This brochure compromises of the proposed design changes to Block A and Phase 1A, which are submitted as a non material amendment to Reading Borough Council.

Block A forms part of a much wider scheme relating to the redevelopment of the St MartIn's Precinct in Caversham which was granted planning permission on 31 March 2015 with Reference No.140997. Block A was redesignated as Phase 1A in a Deed of Variation to the S106 agreement dated 20 April 2017.

3.0 Proposed revised design comparison

Roofscape

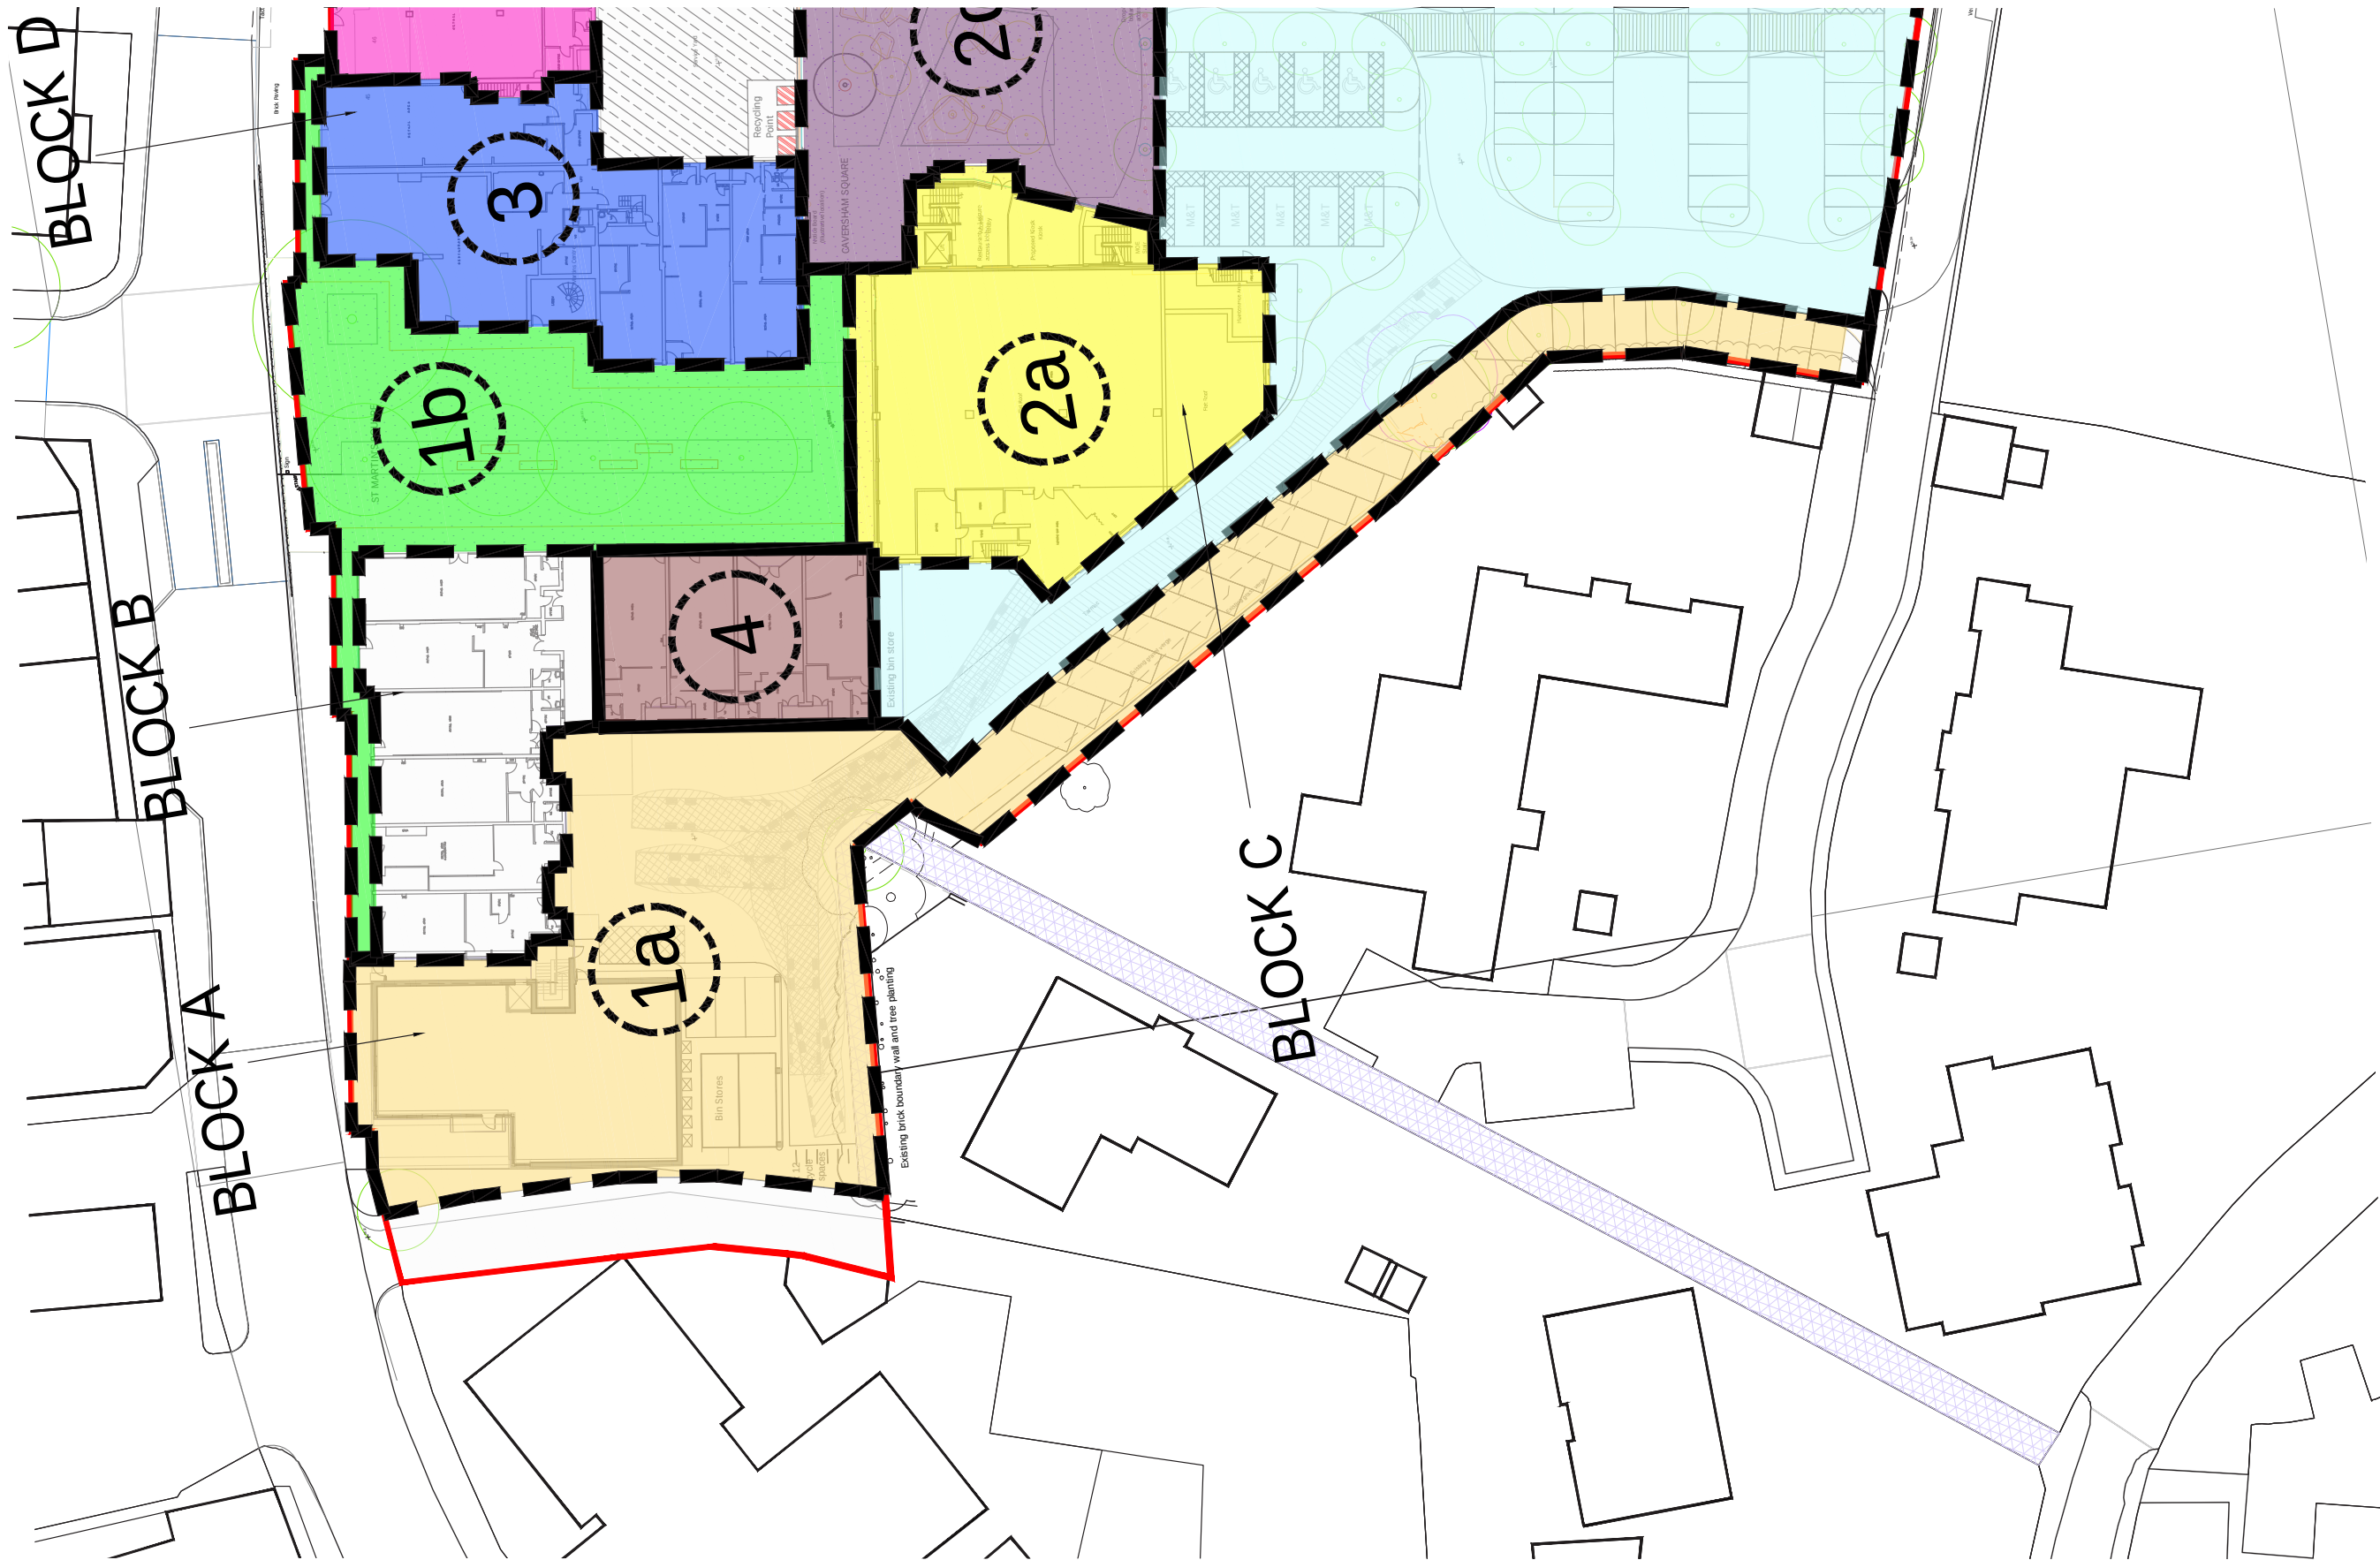
The proposed fourth floor accommodates 2 no. re-configured 2 bed apartments as in the approved scheme and adopts the same footprint. The cladding to the fourth floor is proposed to be the same zinc interlocking panels as the lower elevations although the fenestration arrangements have changed slightly to reflect the revised apartment interiors. The size of the patio doors have increased to soften the elevation and allow more natural light into the principle rooms.

The design of the roofscape of the proposed scheme is similar at 4th floor and roof level to that of the approved scheme in that the parapet levels from the approved scheme have been respected but an enclosure has been added at roof level which contains essential heat rejection restaurant plant (from an assessment made by the M+E engineer and which has been checked against normal commercial requirements), other required plant / vents and the lift overrun none of which were shown on the approved plans.

Access to the new louvred enclosure is from a glazed rooflight to the main stair landing which also serves as an Automatic Opening Vent (AOV) for fire safety purposes.

The louvred enclosure has been designed to be as low as practicable to house the required plant and as limited in plan form as possible and pushed as far to the least visible area from Church Street as possible. The tallest point of the enclosure is the smoke exhaust vent that serves the residential common parts and is required for fire safety which protrudes slightly above the enclosing walls. The walls are proposed to be clad in silver grey louvres that minimise visual impact when seen against the sky.

Facade maintenance and window cleaning requirements have led to a 1.8m clear zone around the perimeter of the roof, inside which a 400mm high enclosure screens a PV panel array which is required to comply with sustainability requirements. Sustainability pre-assessments have been undertaken for residential and commercial uses that have demonstrated PV provision for Block A. The required number of PV panels are to be located on the roofs of Blocks A and B. Rooflights to apartment hallways are also included and enclosed within this screen.
